Re: Indian Point Unit No. 2
Docket No. 50-247
NL-04-073

SUBJECT: **Reply to Request for Additional Information Regarding
Indian Point 2 Stretch Power Uprate (TAC MC1865)**

**REPLY TO NRC REQUEST FOR ADDITIONAL INFORMATION REGARDING
PROPOSED LICENSE AMENDMENT REQUEST FOR
INDIAN POINT 2 STRETCH POWER UPRATE**

Figure PVM-5
Probability of Correct Rejection
Sizing, Std. Dev. = 0.12, Acceptable Flaw Size 0.15

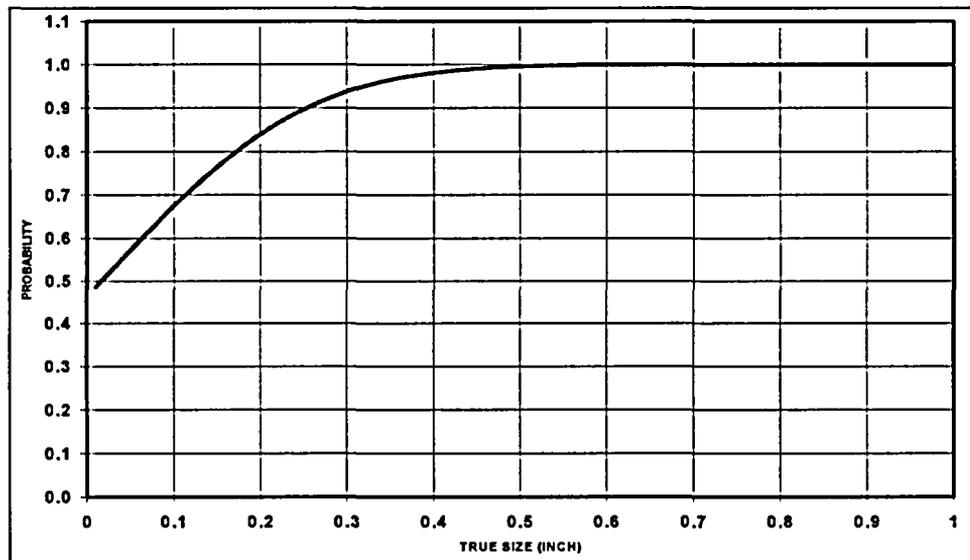
- a. Identify the references for the report that justifies the use of a 1/5 T defect for the outlet nozzle to shell weld. Identify whether the analysis satisfies the requirements of Article G-2220 of Section XI of the ASME Code.
- b. Describe the non-destructive inspection technique which will be utilized to examine the nozzle inner radius at the outlet nozzle to shell region.
- c. Provide the data and describe the analysis that the probability of detecting a flaw with a depth of 0.5-inch is greater than 99.9%.

Figure PVM-5 depicts the expected rejection probability as a function of flaw size. Correct rejection probability considers the detection capability and the sizing capability for flaws. For example, as shown in Figure PVM-5, the probability of detecting and rejecting a flaw 0.25 inch into the base material is equal to or greater than 90%.

Figure PVM-2-9:
Probability of Correct Rejection/Reporting (PCR) Considering Only Passed Candidates, Appendix VIII from the Outside Surface. Reporting Criterion $A' = 0.15$ inch.]

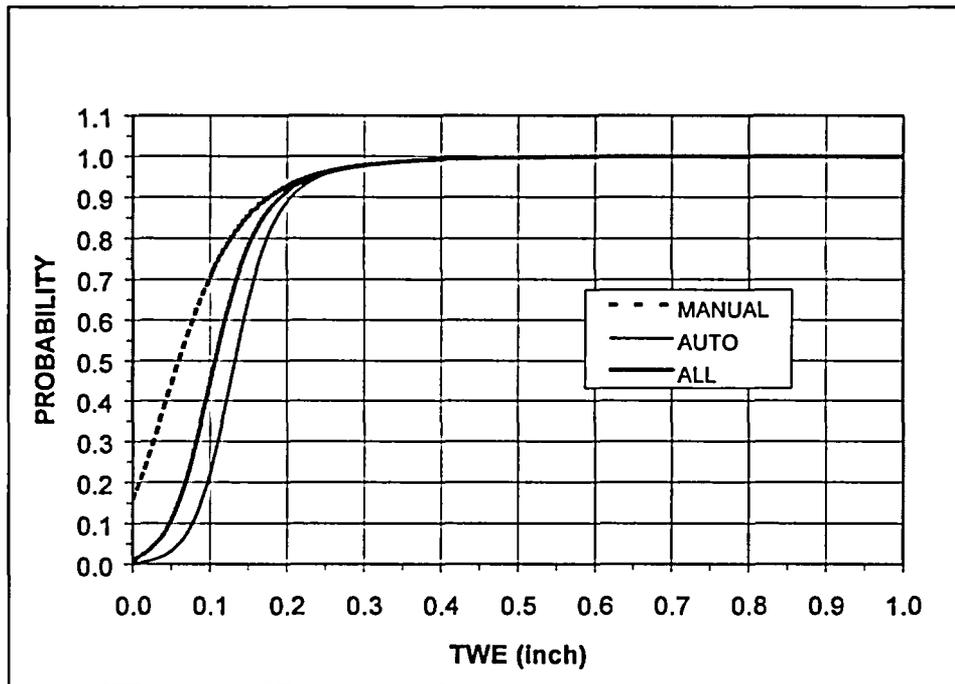
- Describe the analysis that determined a 0.50-inch flaw depth for the safety and relief nozzle (corner) and a 0.15-inch flaw depth for the upper shell will meet the fracture toughness requirements of Appendix G of the ASME Code.
- Identify whether the analysis satisfies the requirements of Article G-2220 of Section XI of the ASME Code. Does the analysis for the safety and relief nozzles and upper shell satisfy these structural factors?
- Describe the non-destructive examination technique which will be utilized to inspect the safety and relief nozzles and upper shell.
- Provide the data, a description of the analysis, and the probability of detection of flaws with a depth of 0.50-inch for the safety and relief nozzle and 0.15-inch for the upper shell.

The PODs for the safety and relief nozzle and the upper shell are taken from EPRI Report, "Justification for the Reduction of Inspection Requirements for the Boiling Water Reactor Nozzle-to-Vessel Shell Welds And Nozzle Blend Radii (VIP-108)", R. Carter, June 2002. This report is deemed applicable as the shell thickness and nozzle diameters are similar. As shown in the following figure the PODs of flaws with a depth of 0.50-inch for the safety and relief nozzle and 0.15-inch for the upper shell are 99.9% and 85%, respectively.
